RFI #: 61  
 Date: 2/22/2012  
 Job: EB-02 Keller Springs Lofts  
 Phone: 877-777-5115

CC: David Gallagher (Embrey Builders LLC)  
 Subject: Fire Extinguisher Cabinets Locations

RFI #: 176  
 Date: 8/2/2012  
 Job: EB-02 Keller Springs Lofts  
 Phone: 877-777-5115

Subject: Support angle iron needed and gusset detail needed

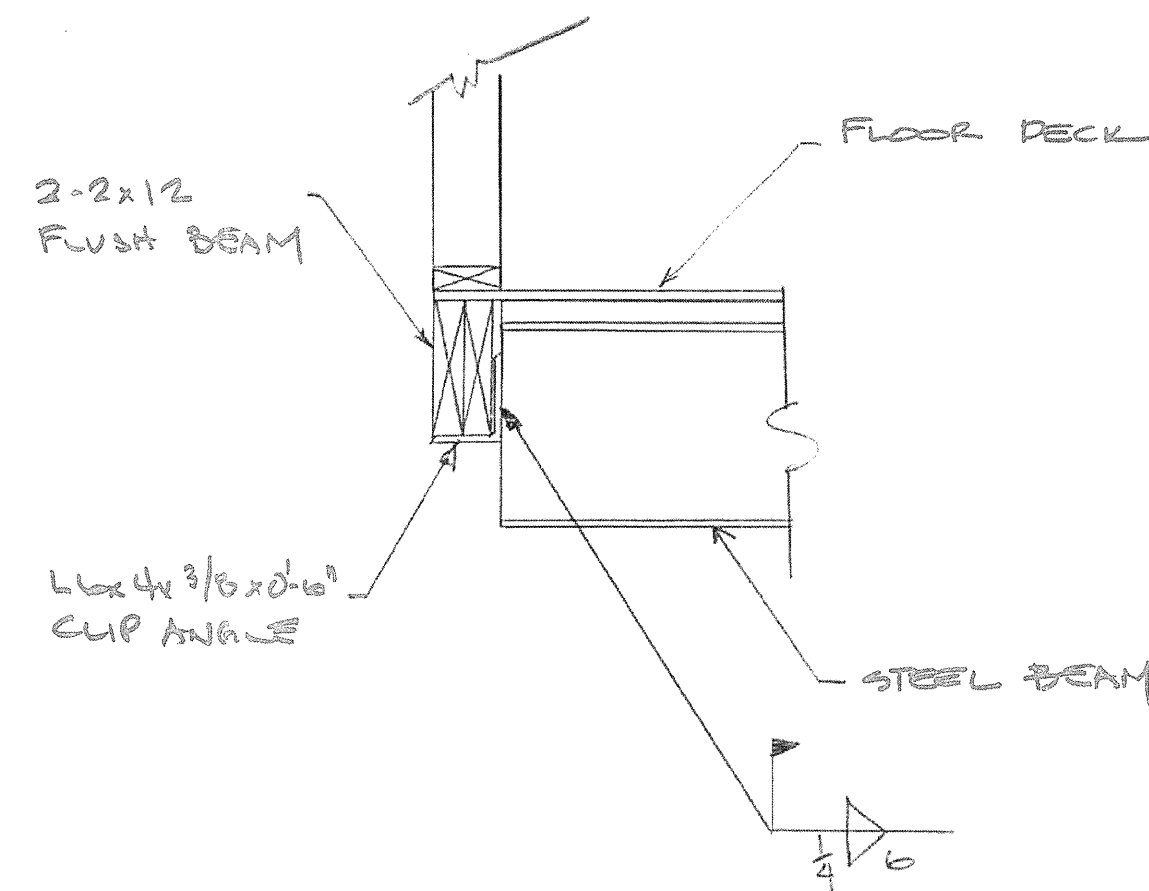
**Request:** Date Required: 8/2/2012  
 On sheet 3.2A the highlighted wall between the B2 unit and the stair tower is 5'-12" past the steel. Our conversation on site please specify what size angle to weld to beam and install 2x10 or 2x12 to support the wall. Please provide gusset detail to support the areas highlighted on the A2-SP unit per our conversation onsite, and per the attached sketches.

**Response:**  
 See attached details.
